**PROJECT:** Town of Wedowee  
CWSRF Project No. CS010883-02 & CS010883-04  
ARC Project No. AL-20358-2021  
KG Project #20-0016

**ADDENDUM NO.** One (1)

**DATE:** September 13, 2023

**TOWN OF WEDOWEE**  
**SEWER SYSTEM IMPROVEMENTS**  
**CWSRF PROJECT NO. CS010883-02 & CS010883-04**  
**ARC PROJECT NO. AL-20358-2021**  
**KG PROJECT NO. 20-0016**  
**THURSDAY, SEPTEMBER 7, 2023, AT 1:00 P.M.**

SHEET NO. **9**

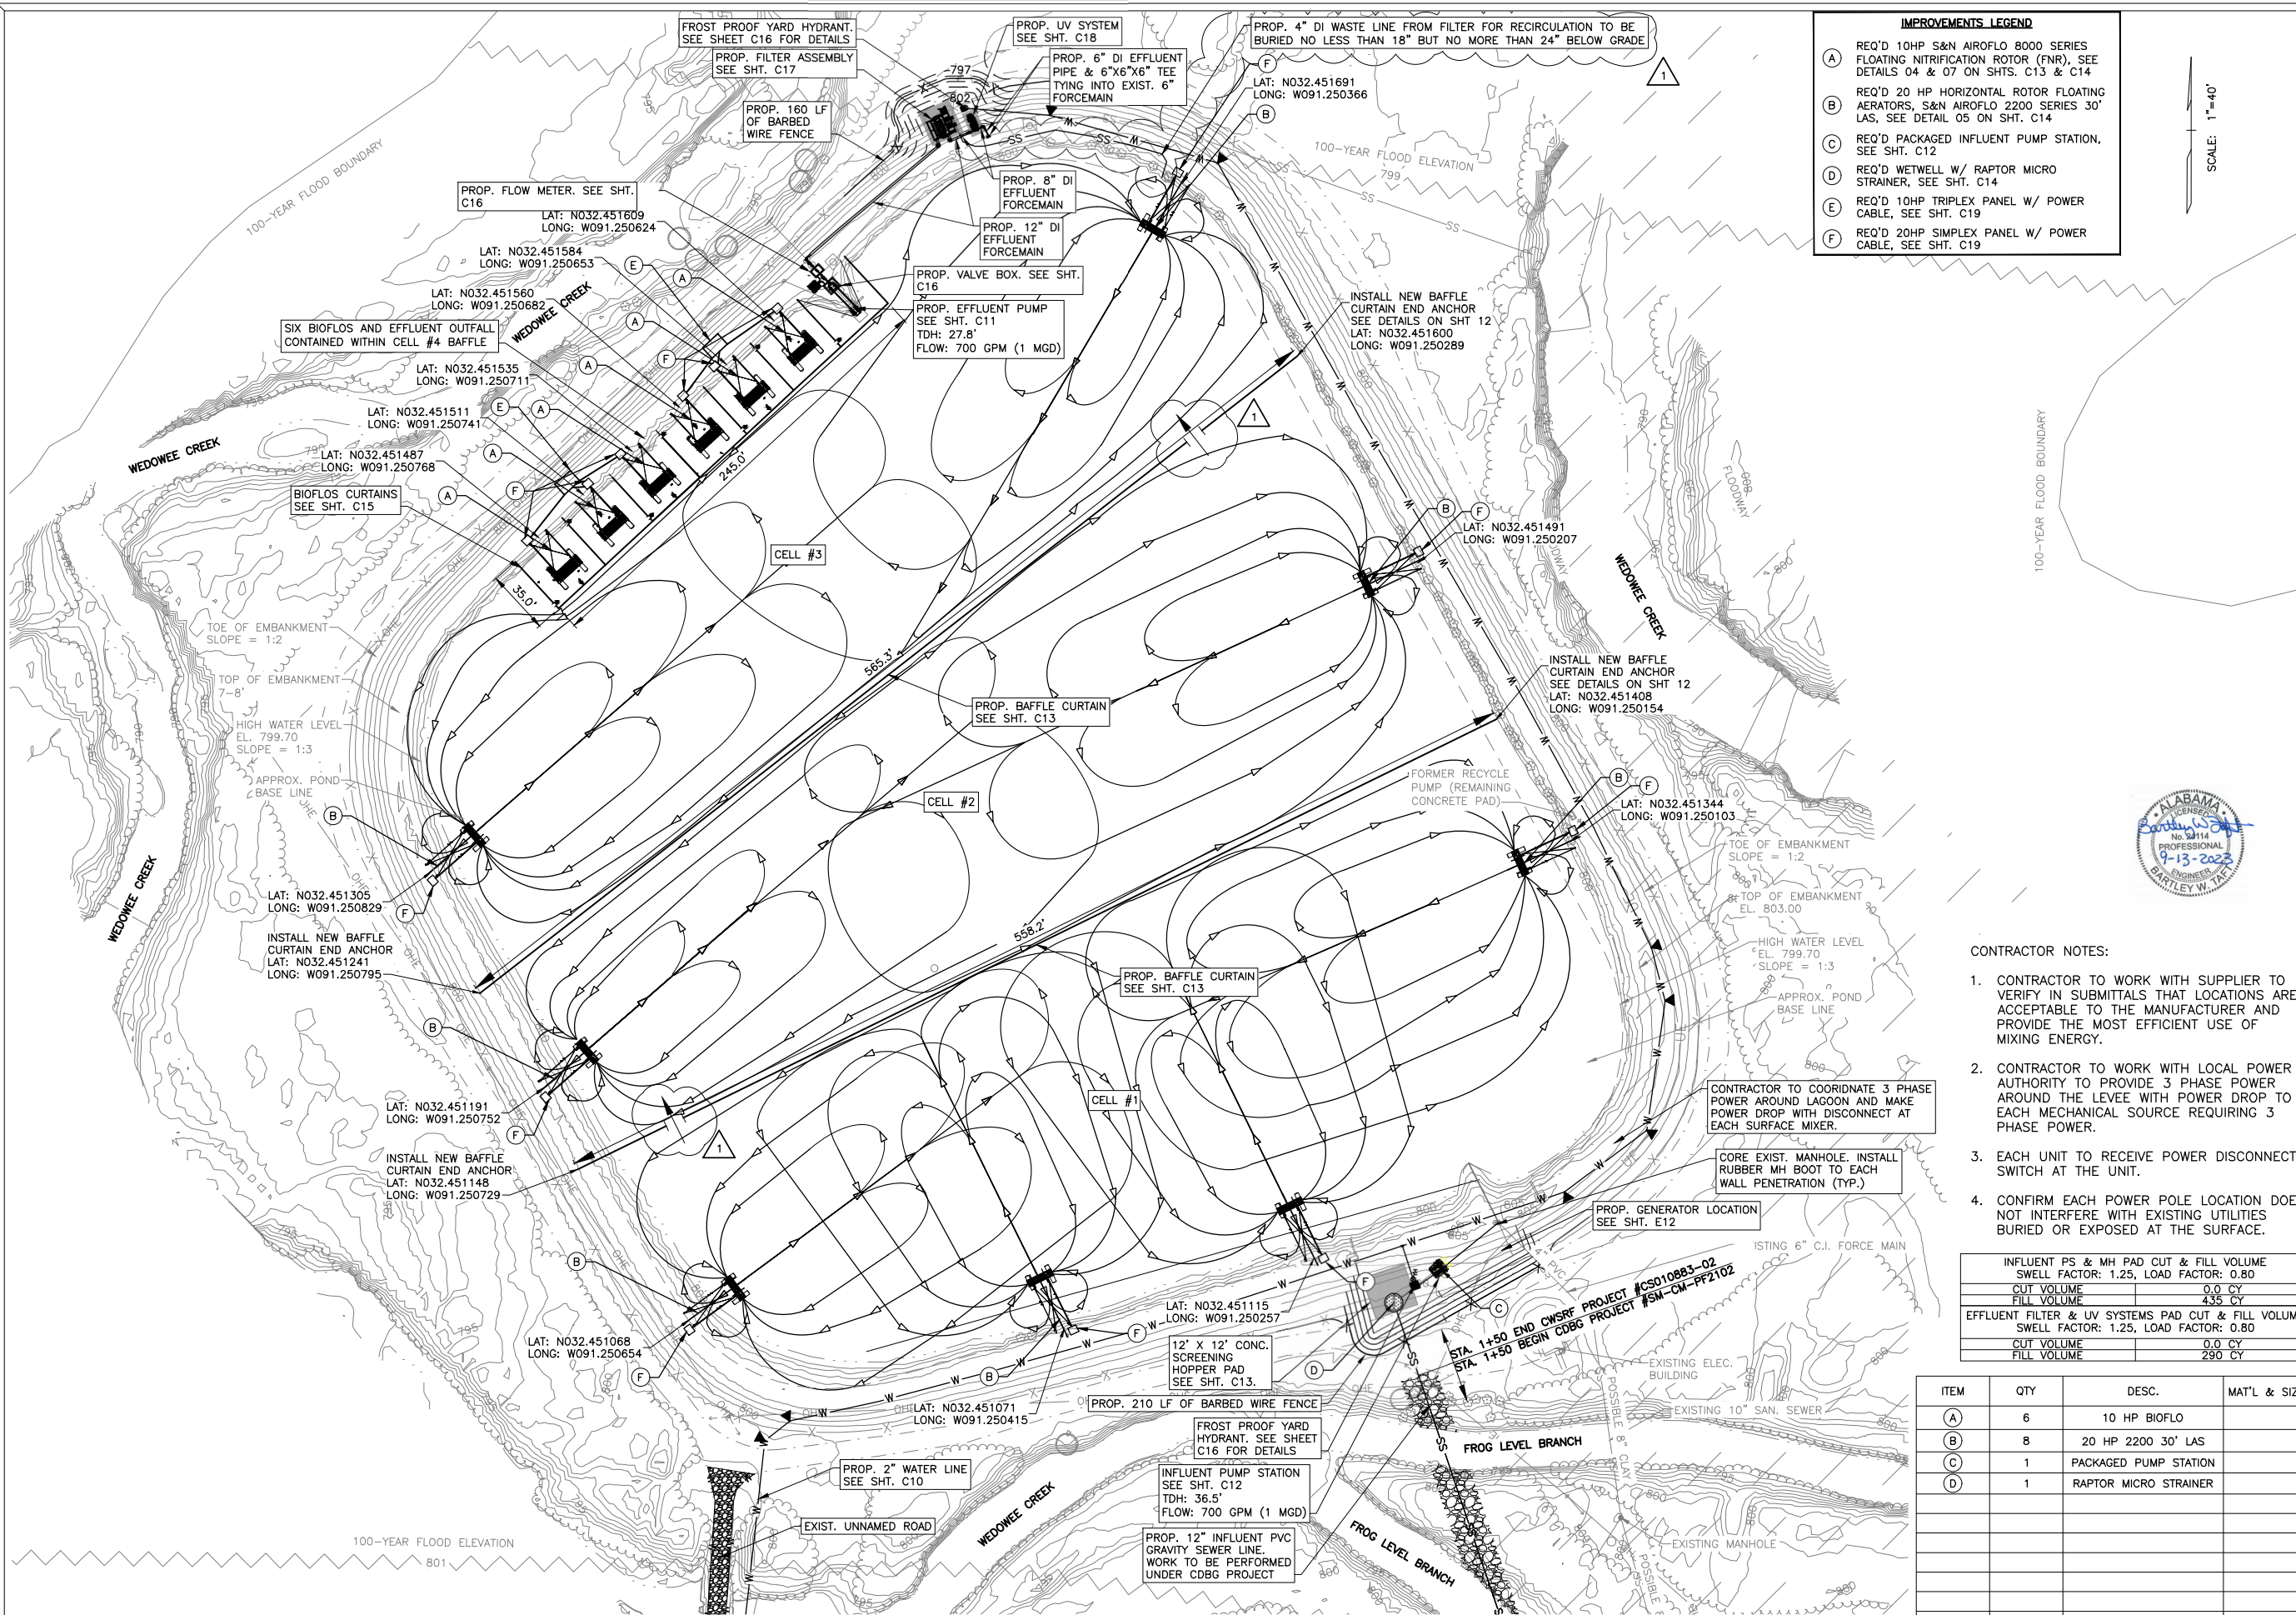
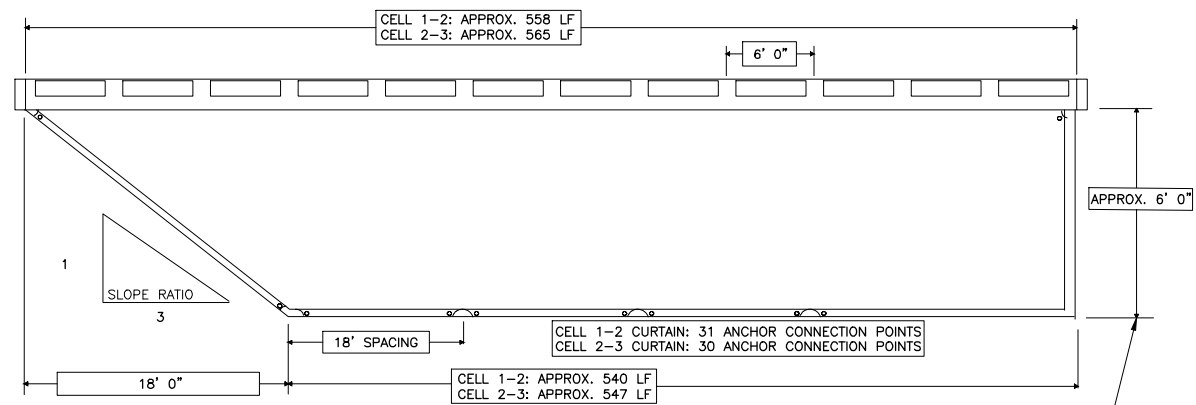
6. Please see revised Sheet C13 attached hereto for dimensions of manhole base for influent screen.
7. Please see portion of revised Sheet C9 attached hereto for addition of filter backwash pump discharge line.
8. The Engineer's estimate of probable cost for the labor contract is \$2,285,000.00

SHEET NO.  
**C17**

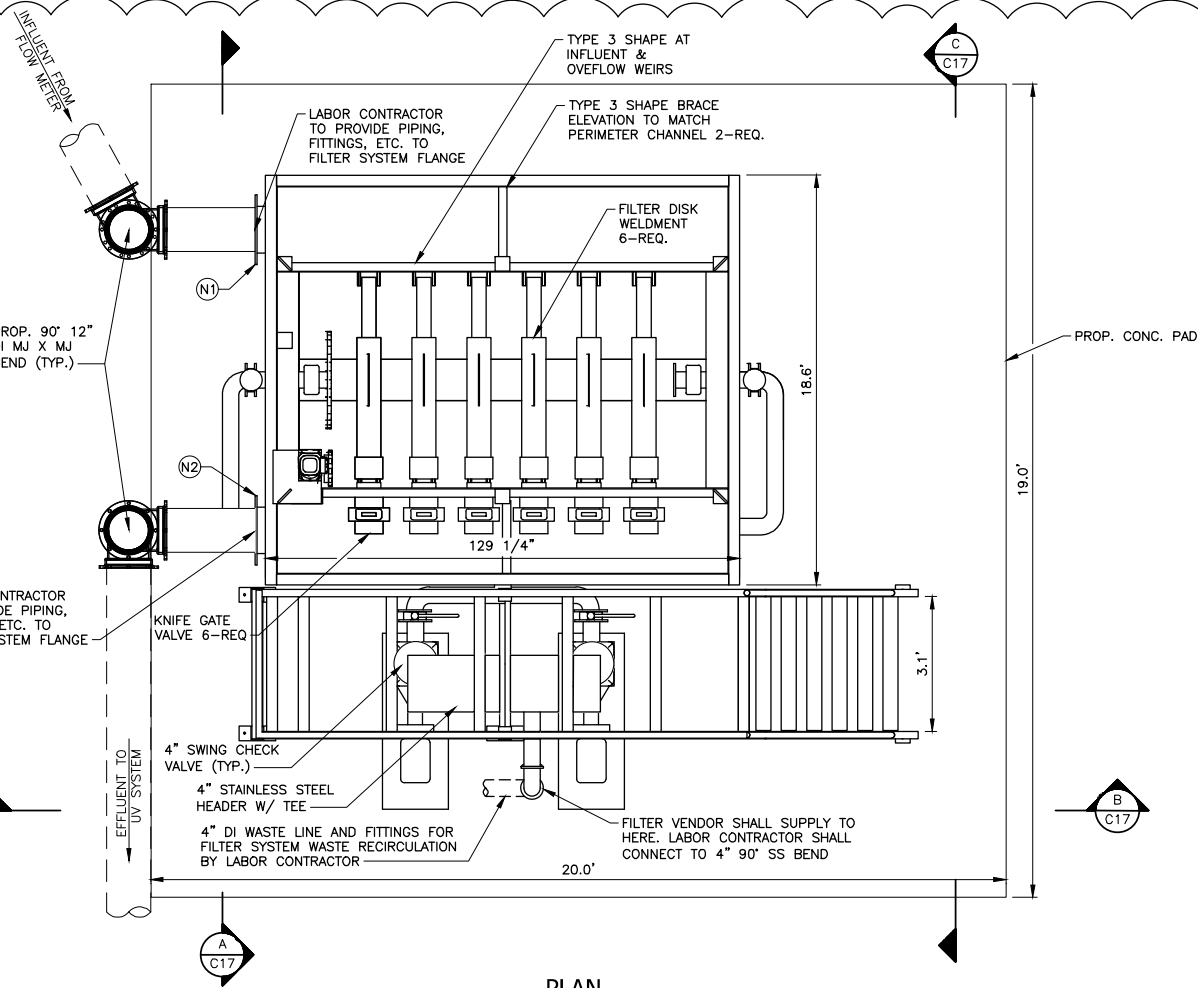
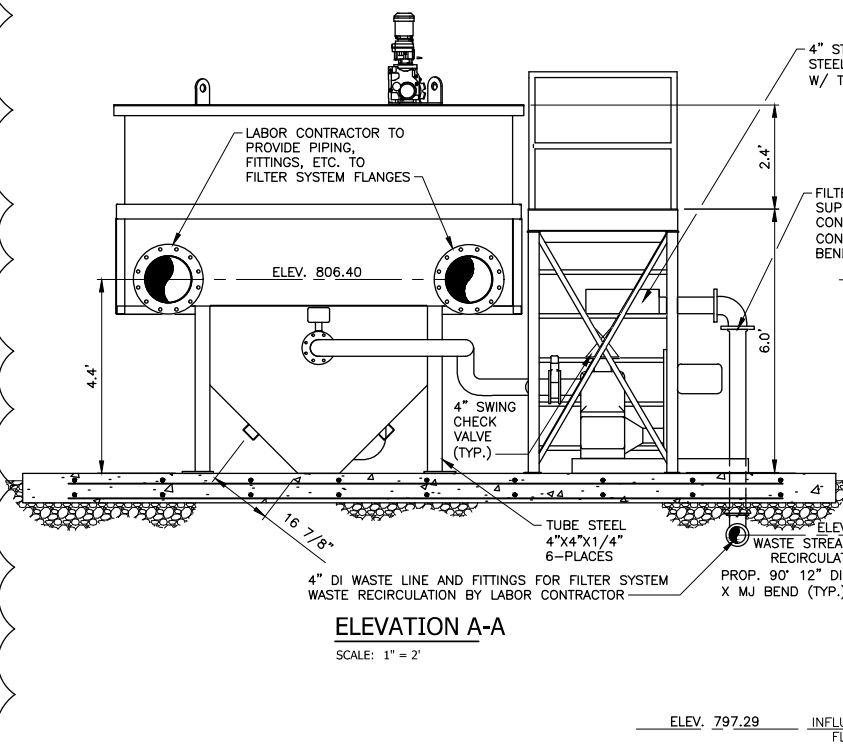
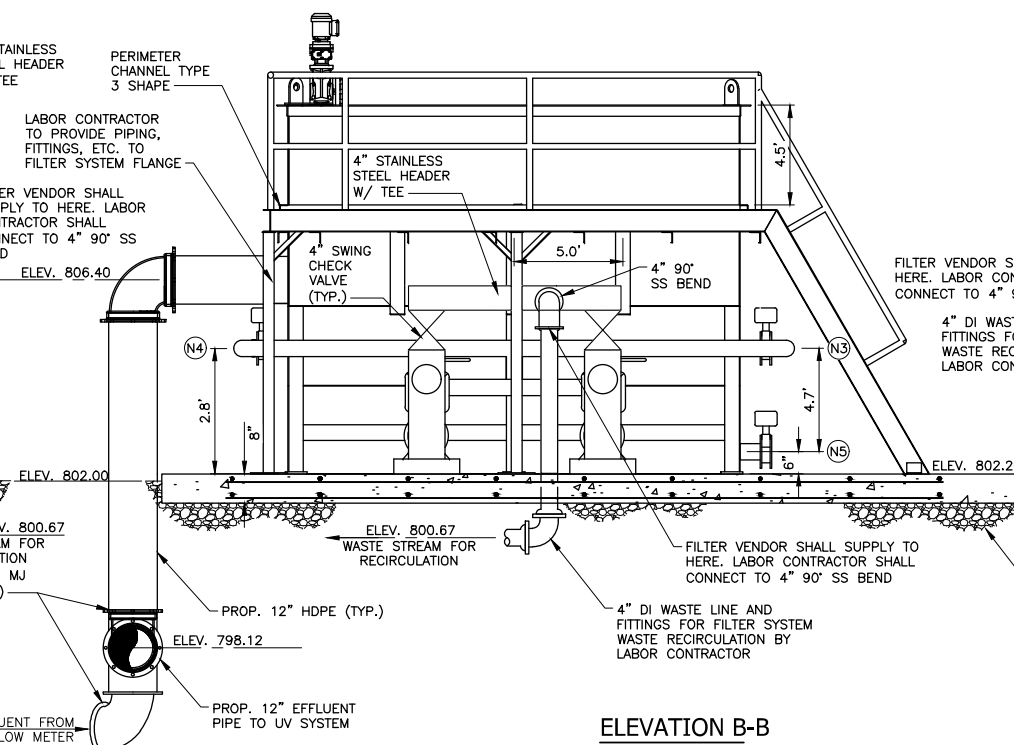
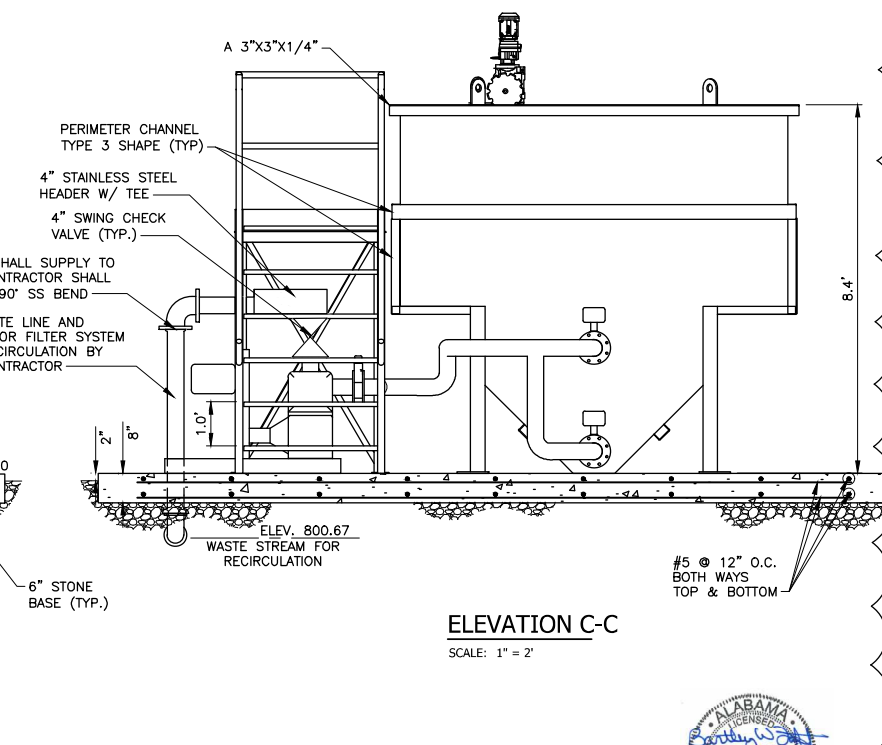
A: There is not a page 339. Section 40 71 12 ELECTROMAGNETIC FLOW METER, 1.03.A. shall now read: "The 4" flow sensor tube shall be constructed of 304 stainless-steel lined with NSF61 rated Polypropylene and rated for a working pressure up to 285 psi."
5. Grounding rings shall be included with flow meter equipment as shown in equipment cut sheets from named flow meter manufacturer included in the contract documents.
6. Battery backup for flow meter shall be furnished and installed by the labor contractor.
7. 10 m of cable for flow meter is acceptable.
8. JPS Industries, Inc. is approved as an equal manufacturer to the baffle curtain manufacturer listed. All material shall be XR-5 grade and shall be constructed per specifications noted in the contract documents.
9. Access platform, piping between backwash pumps and filter tank, backwash pumps discharge

check valves, and backwash pumps discharge header shall be provided by the filter manufacturer. See revised sheet C17 attached hereto for reference.
